Council Assessment Panel Agenda & Reports

18 March 2024

5.1 DEVELOPMENT NUMBER 23034692 – BEN HOCK – 32 CHAPEL STREET, NORWOOD

DEVELOPMENT NO.:	23034692
APPLICANT:	Ben Hock
ADDRESS:	32 CHAPEL ST NORWOOD SA 5067
NATURE OF DEVELOPMENT:	Change of use to indoor recreation facility (martial arts studio- Taekwondo)
ZONING INFORMATION:	<p>Zones:</p> <ul style="list-style-type: none"> • Business Neighbourhood <p>Overlays:</p> <ul style="list-style-type: none"> • Airport Building Heights (Regulated) • Prescribed Wells Area • Regulated and Significant Tree • Traffic Generating Development <p>Technical Numeric Variations (TNVs):</p> <ul style="list-style-type: none"> • Maximum Building Height (Levels) (Maximum building height is 2 levels)
LODGEMENT DATE:	24 Nov 2023
RELEVANT AUTHORITY:	Assessment panel/Assessment manager at City of Norwood, Payneham and St. Peters
PLANNING & DESIGN CODE VERSION:	P&D Code (in effect) - Version 2023.17 23/11/2023
CATEGORY OF DEVELOPMENT:	Code Assessed - Performance Assessed
NOTIFICATION:	Yes
RECOMMENDING OFFICER:	Edmund Feary Senior Urban Planner

**32 CHAPEL STREET NORWOOD
PROPOSED DEVELOPMENT
PARKING LAYOUT
CONCEPT PLAN**

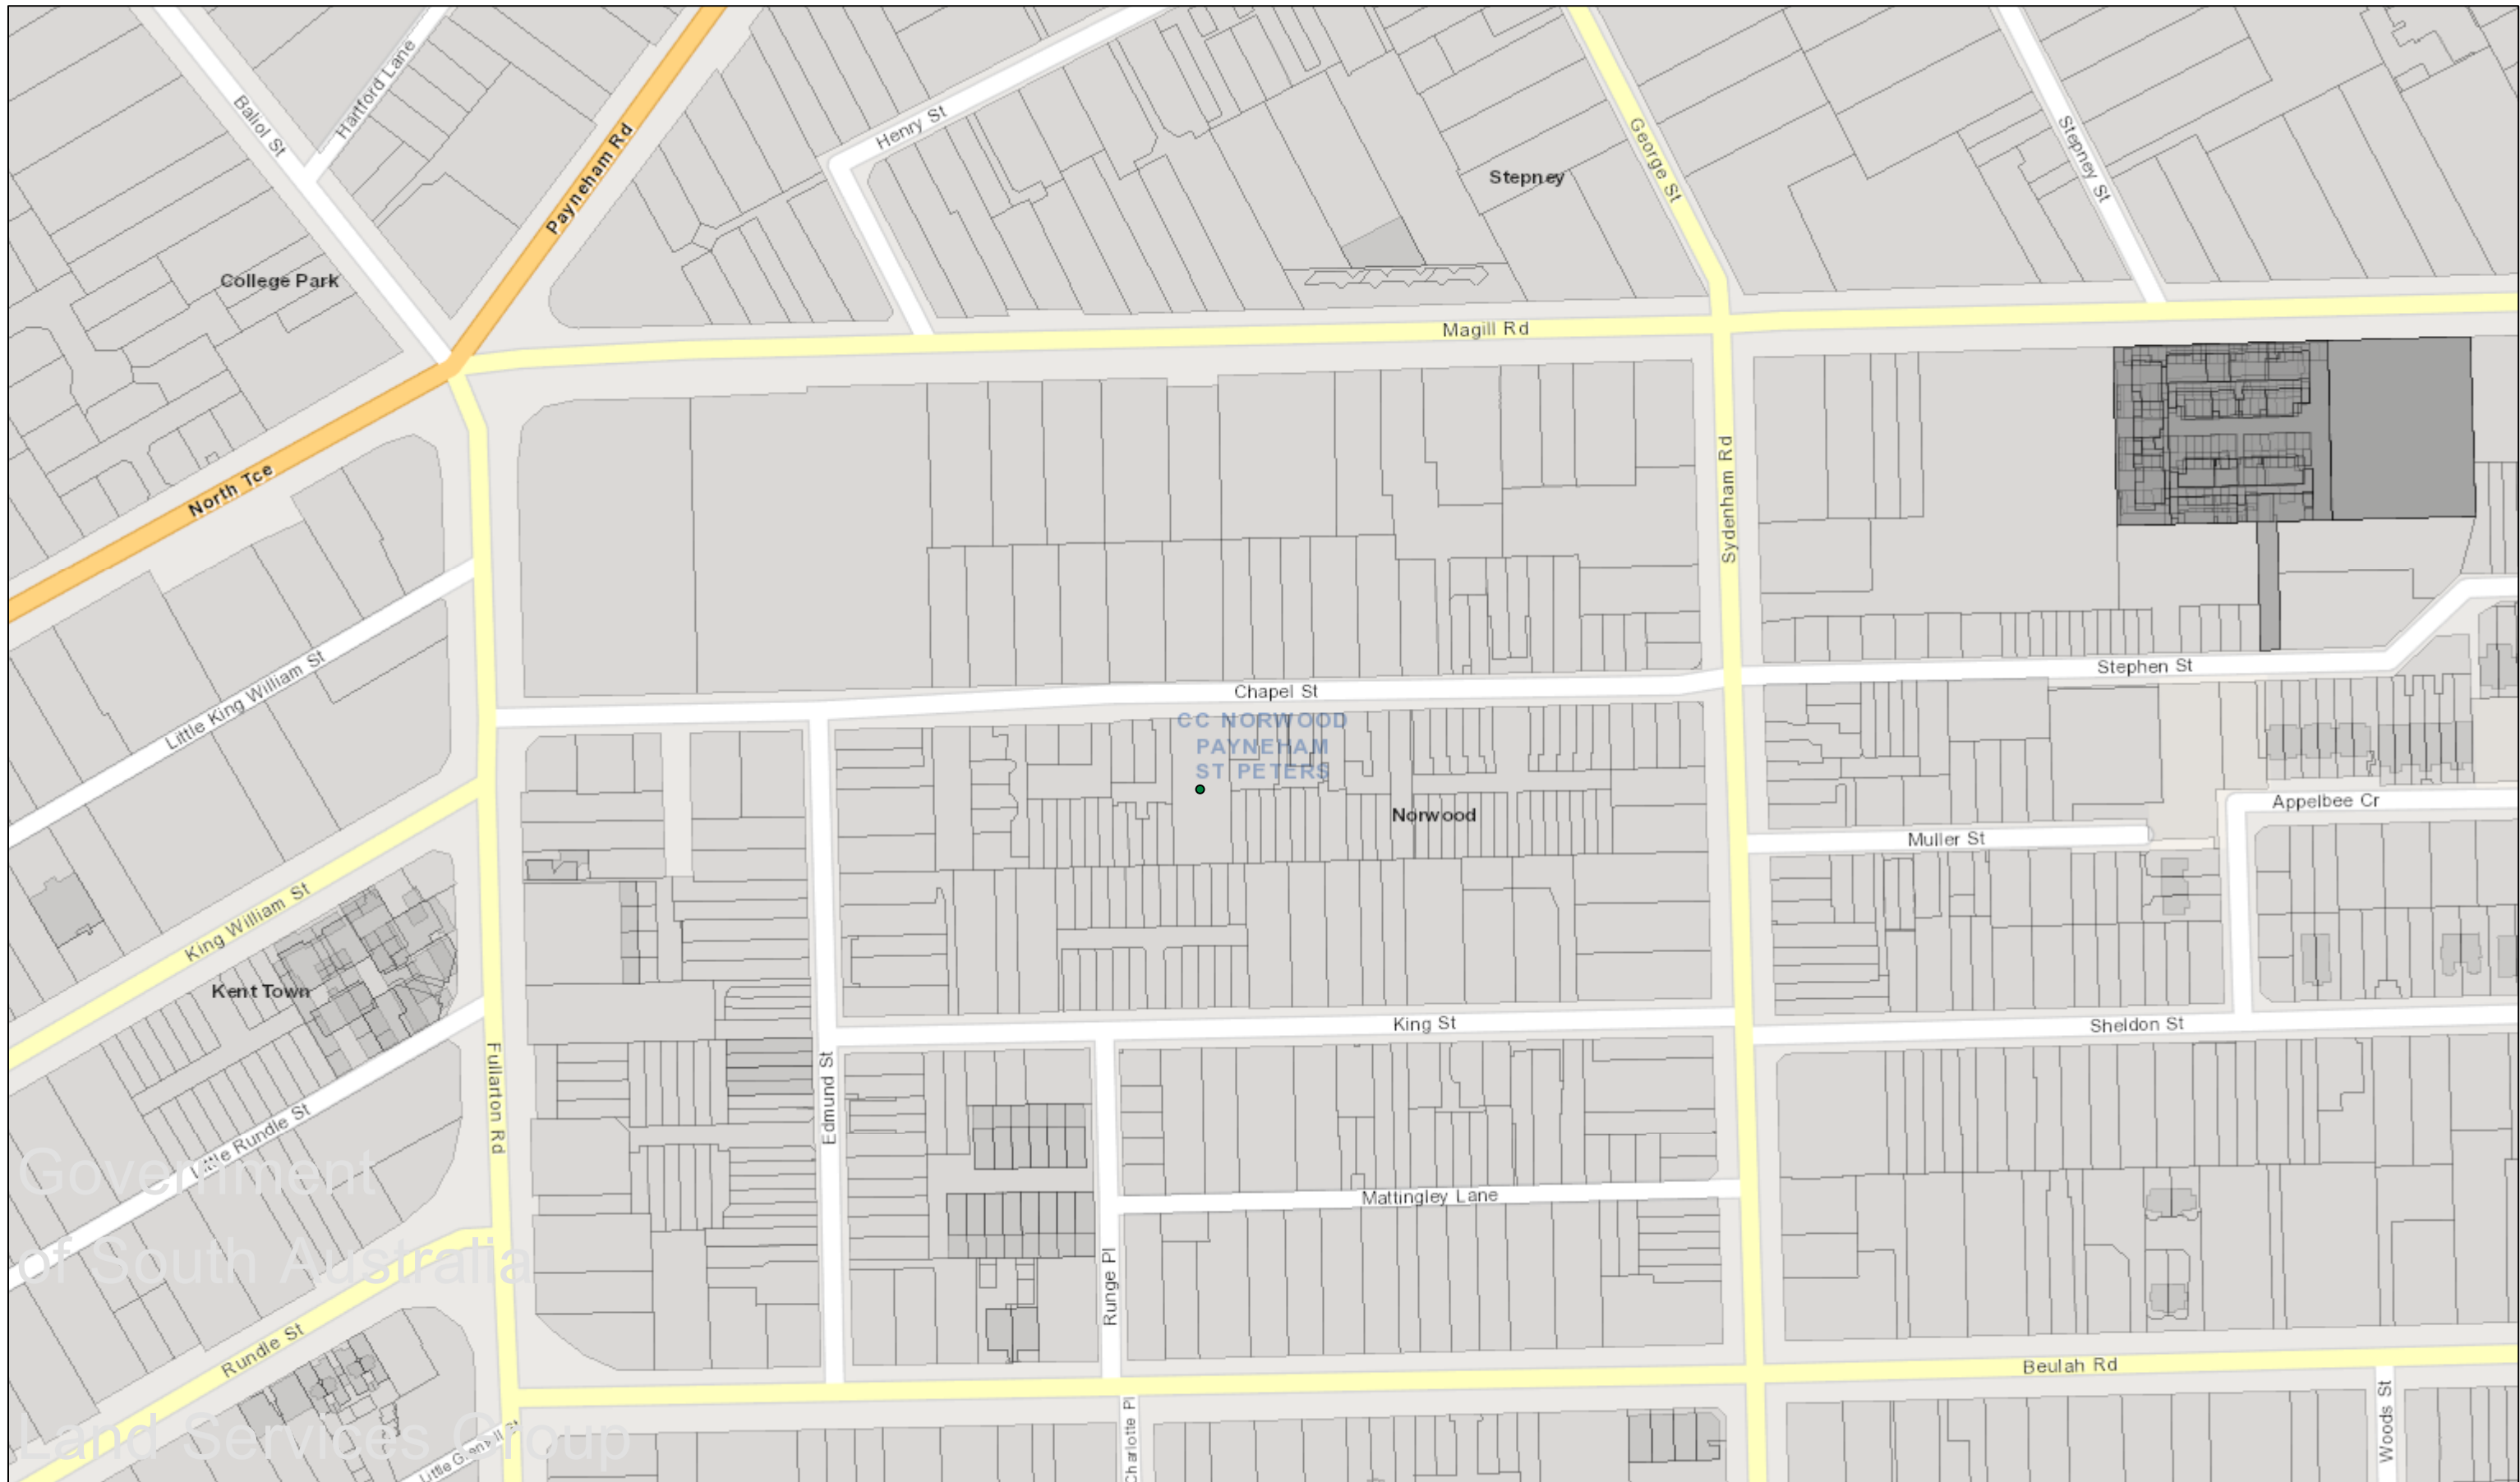
- A site plan showing how the site will operate, existing car park dimensions and demonstrated vehicle movements including a turnaround onsite for parents that may be pulling in to drop off/pick up. This will confirm the number of car parks and that they operate satisfactorily based on the standards and shown the possibility of drop off and pick up of students being undertaken within the site.*
- On-street occupancy survey undertaken at peak periods on the weekday and weekend covering a reasonable walking distance from the site. Currently on-street car parking occupancy is known to be high, an occupancy survey will confirm this or potentially support the application if nearby parking is shown to be available.*

- A site plan showing how the site will operate, existing car park dimensions and demonstrated vehicle movements including a turnaround onsite for parents that may be pulling in to drop off/pick up. This will confirm the number of car parks and that they operate satisfactorily based on the standards and shown the possibility of drop off and pick up of students being undertaken within the site.

Hence, the proposed site will provide more off-street parking which can be utilised by staff (up to 4 at any time) and could be used for some parking for drop off or collection (i.e. 2-3 spaces in the front yard).

**32 CHAPEL STREET NORWOOD
PROPOSED DEVELOPMENT
STAFF PARKING ACCESS
TURN PATH DIAGRAM**

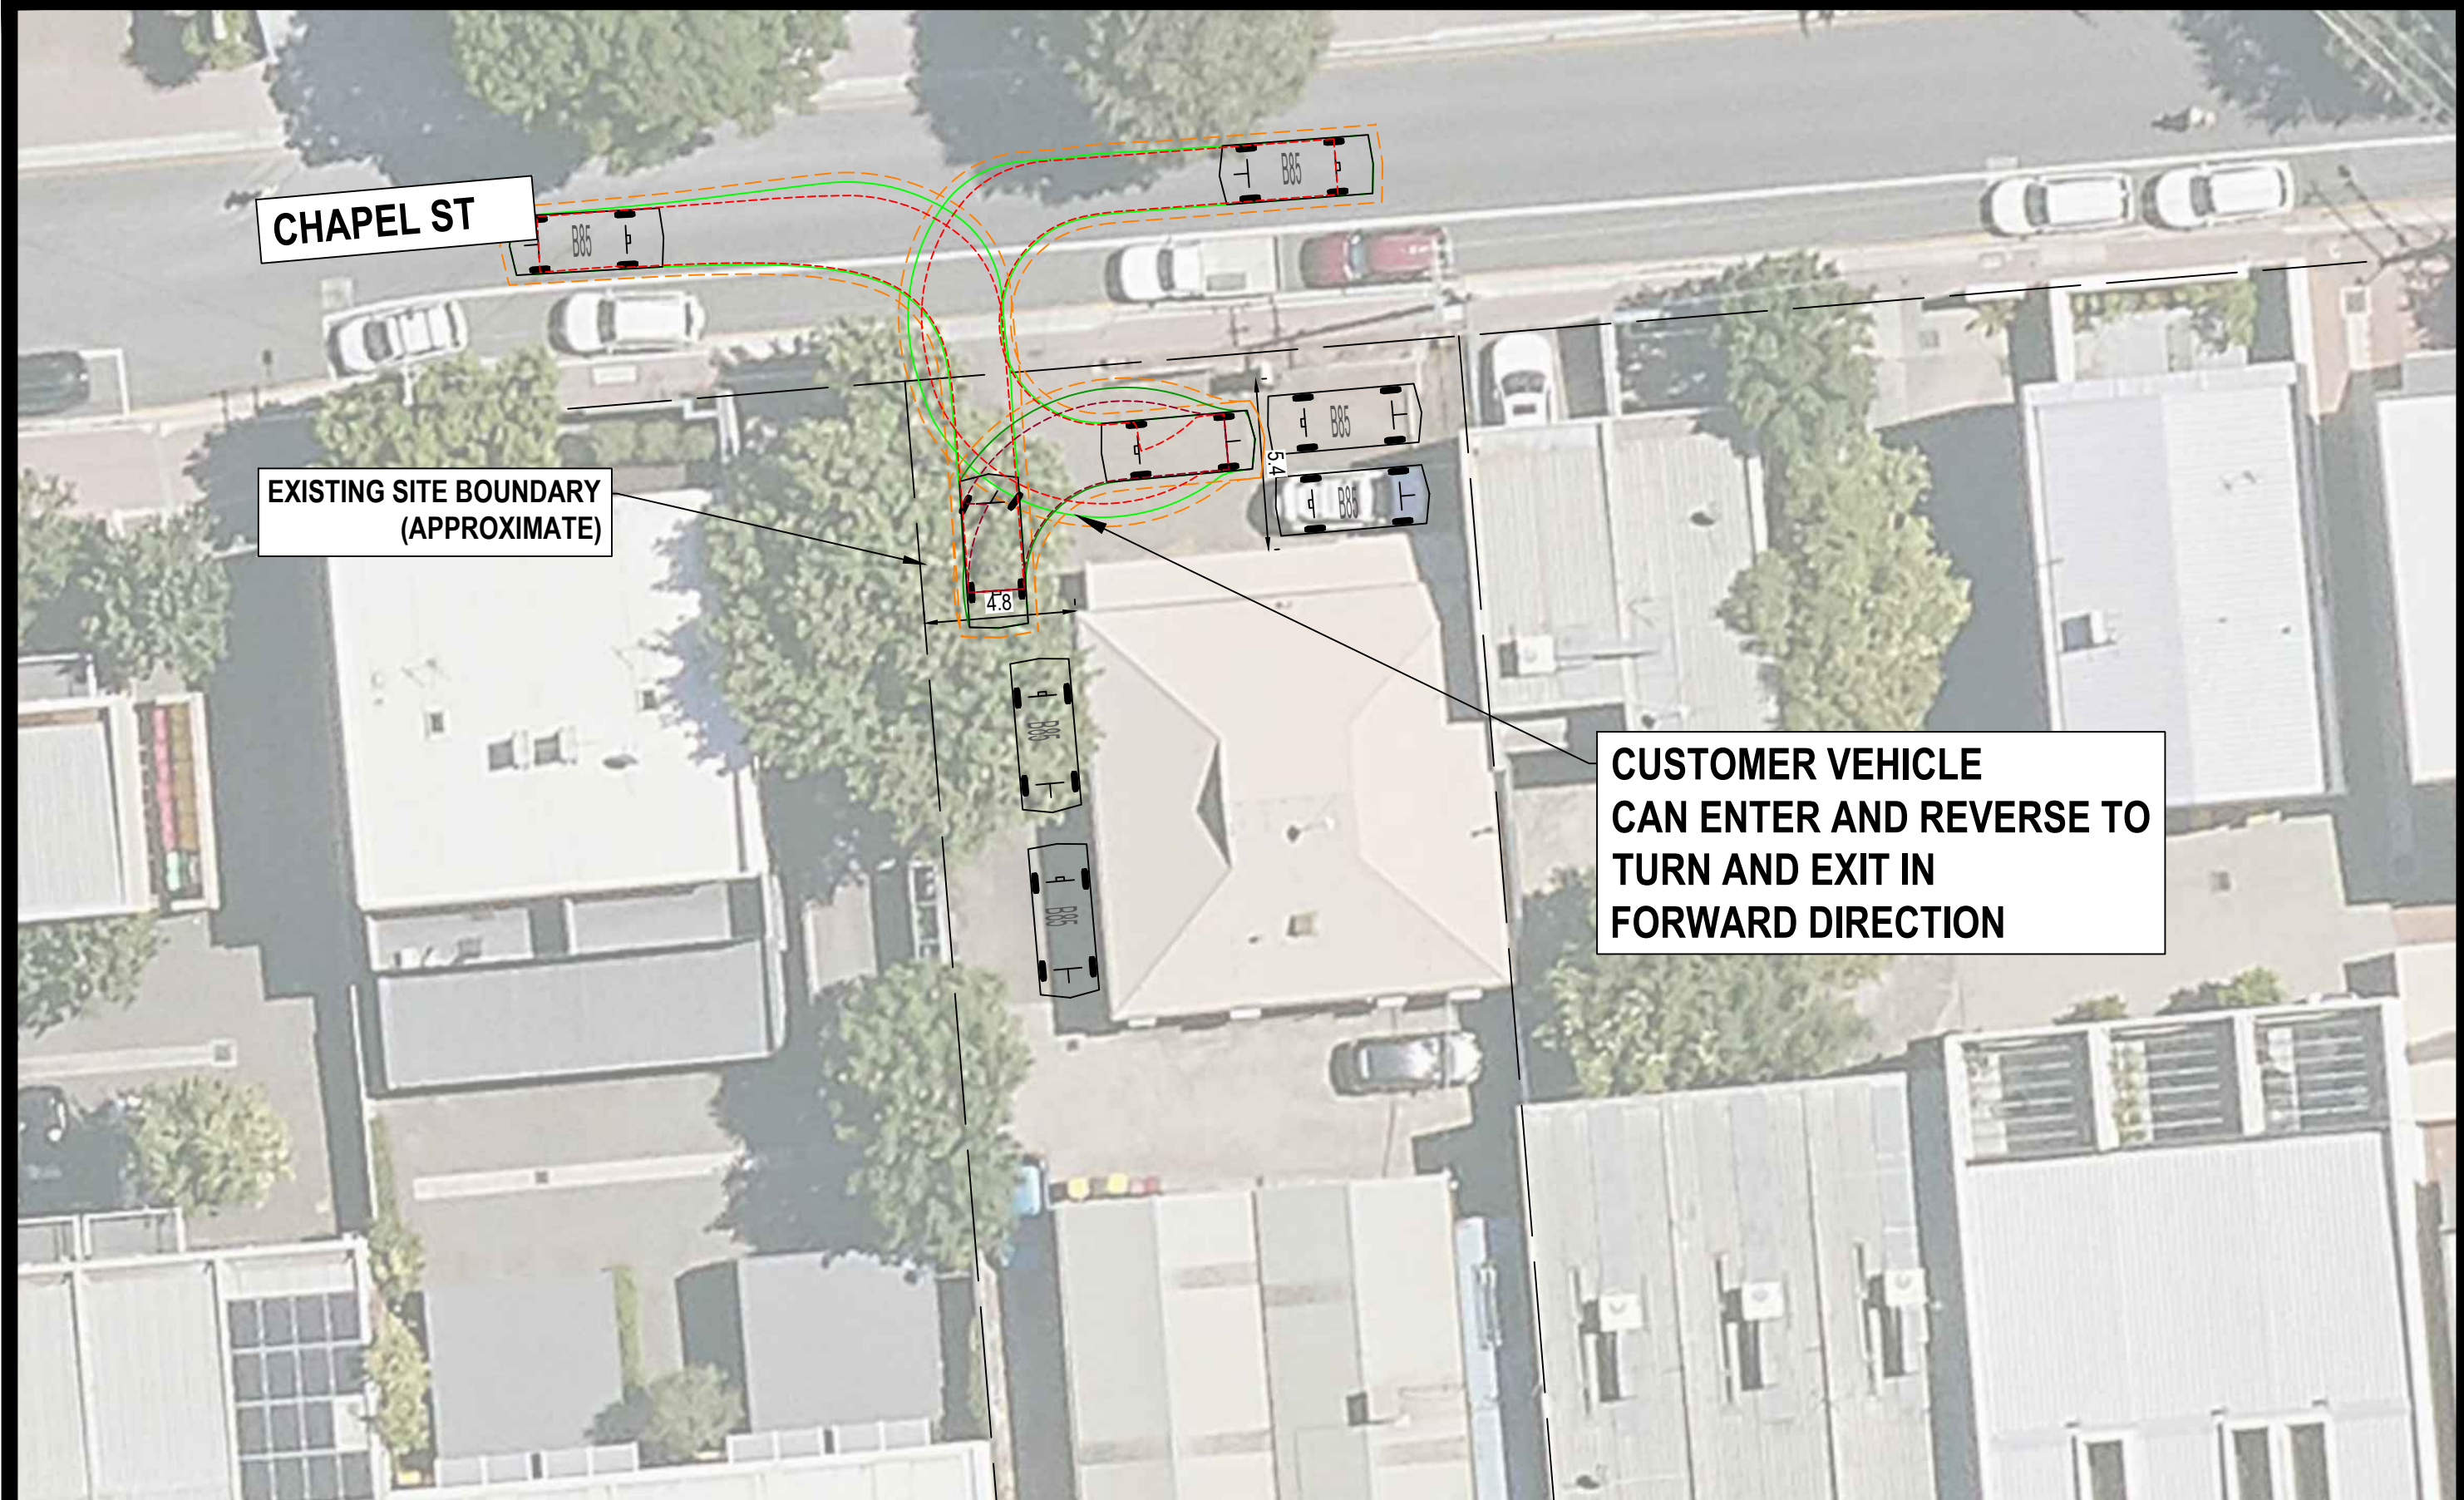
Sorry I could have been clearer there! What we need is a plan which allows us to properly understand the dimensions of the parking spaces and the manoeuvring. I've attached an example from the internet so you can see what I mean. Basically, we need to confirm that the parking spaces shown are actually suitable and will work.
